Bid Bulletin No. 3
July 10, 2020

Public Bidding No. 20-020-5

SUPPLY, DELIVERY, INSTALLATION AND COMMISSIONING
OF AIR-CONDITIONING SYSTEM FOR BUREAU OF QUARANTINE (BOQ)

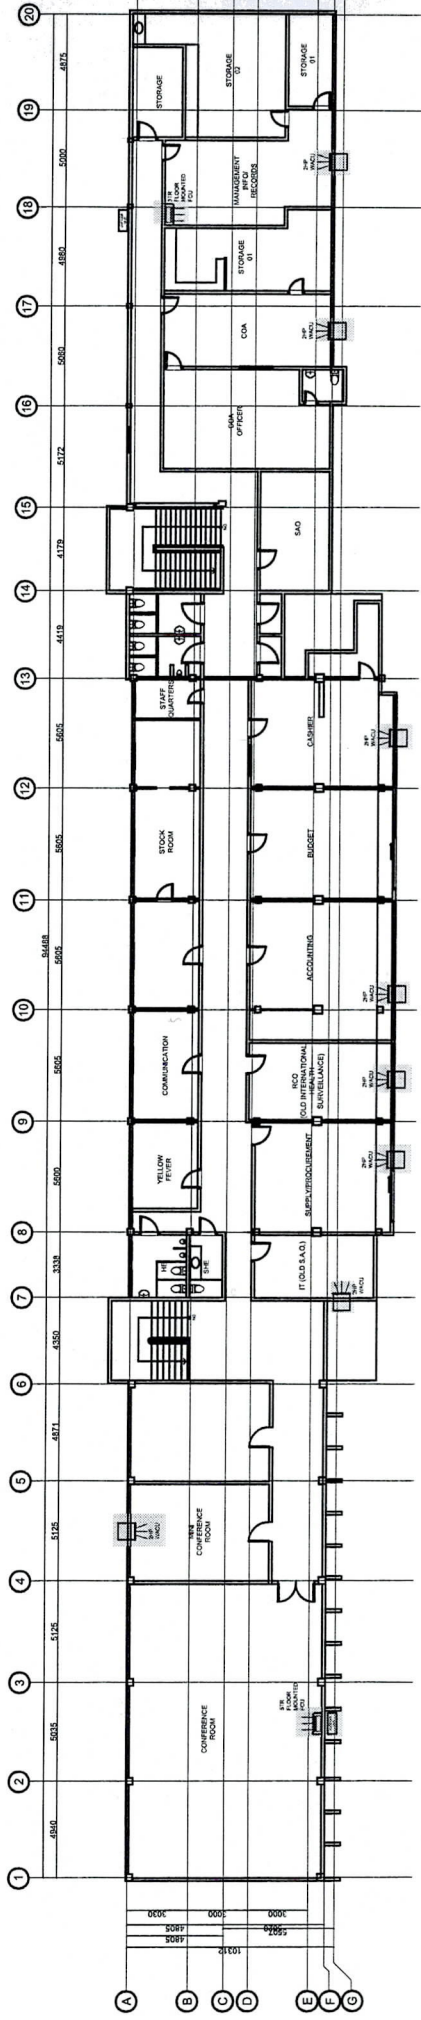
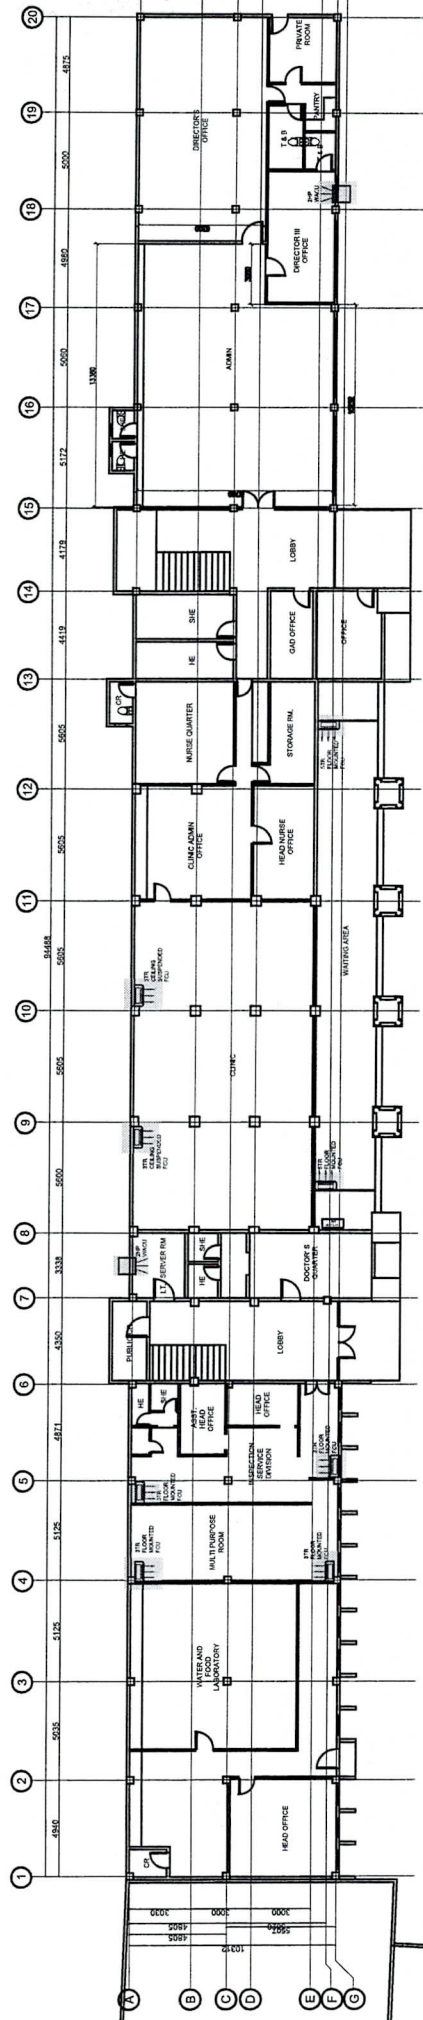
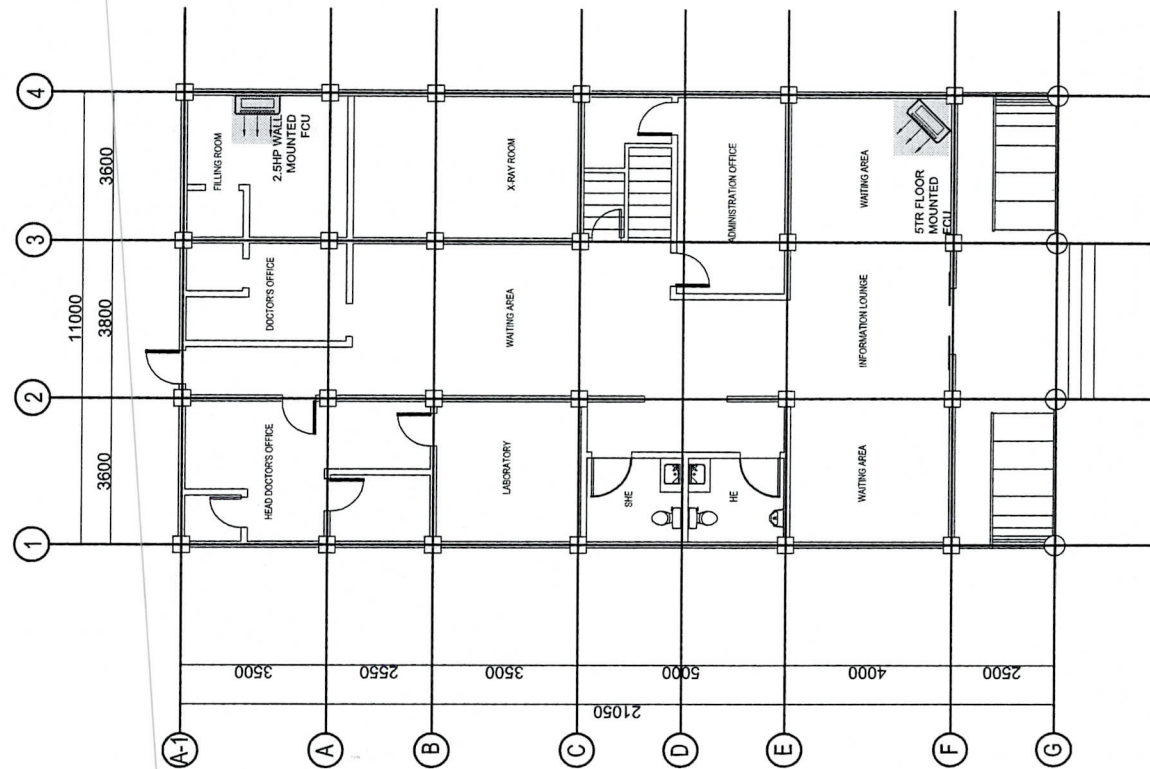
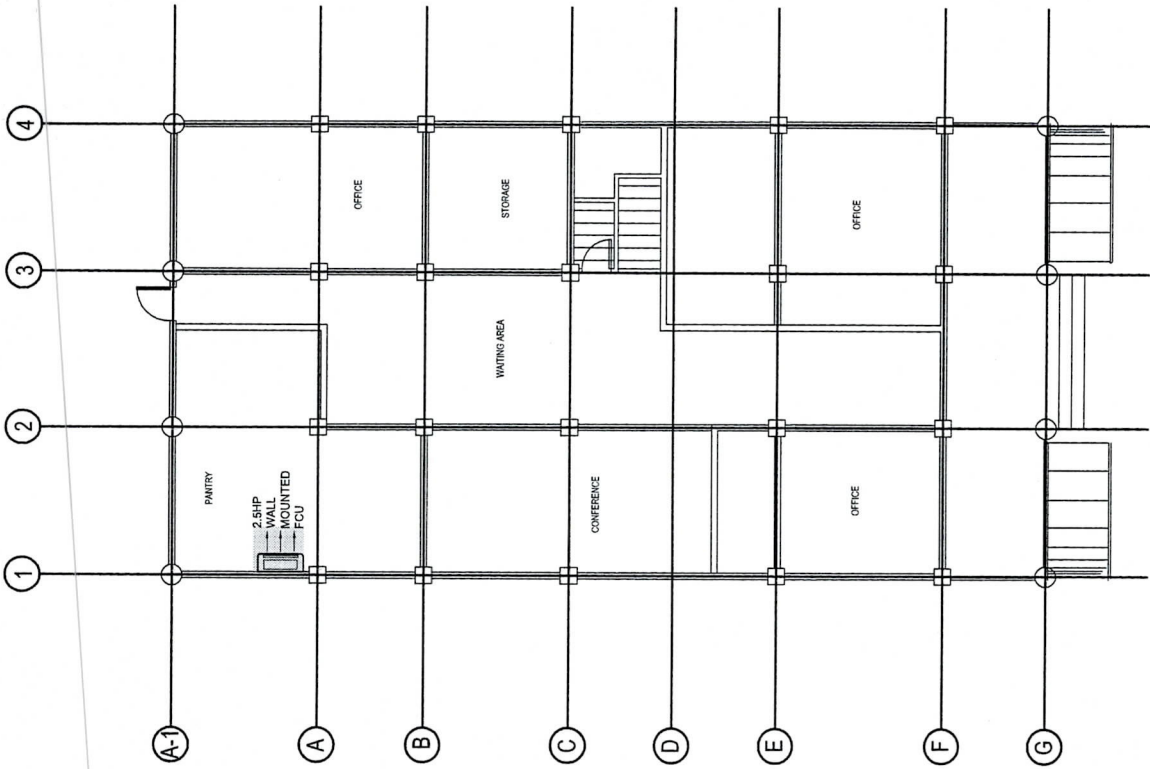
6.	Technical Specifications (Items 1-6)	74-75	A prospective bidder inquired if the plan/layout for air-conditioning unit can be signed and sealed by a Mechanical Engineer, instead of an Electrical Engineer.	As clarified by end-user, the required plan/layout is for electrical to consider the additional load for the split type units for the calculation of new panel boards and feeder lines which is part of the scope. Therefore, plan must be signed and sealed plan by the Professional Electrical Engineer. Please refer to layout attached as Annex "B"

7.	Technical Specifications (Items 1-6)	74-75	A prospective bidder asked for the scope of the installation of the units.	As clarified by end-user, scope of Installation Location is available in the drawings and can be verified through actual site inspection. Please refer to layout attached as Annex "B"
